ATTACHMENT 3A

Emergency Plan Marked-up Pages – Clinton Station

Exelon Standardized Emergency Plan EP-AA-1000
and
Emergency Plan Annex EP-AA-1003

Affected Pages

Figure F-3: NRC Communications for Nuclear Response

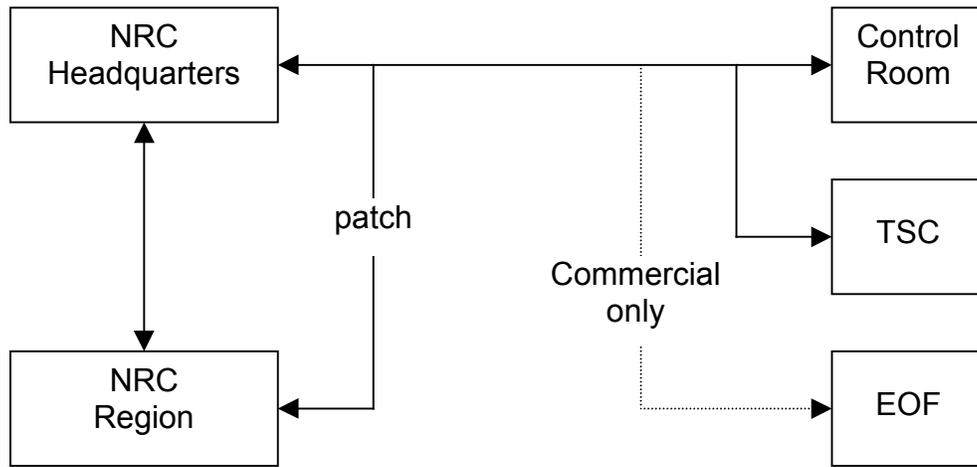
~~Health Physics Network (HPN): There also exists a separate dedicated telephone between the NRC, the TSC, and EOF for conveying health physics information to the NRC as requested or as an open line.~~

NOTE: ENS ~~and HPN~~ circuits may use the Federally maintained system, company tie lines or PBX as dedicated primary communications systems and have commercial backups.
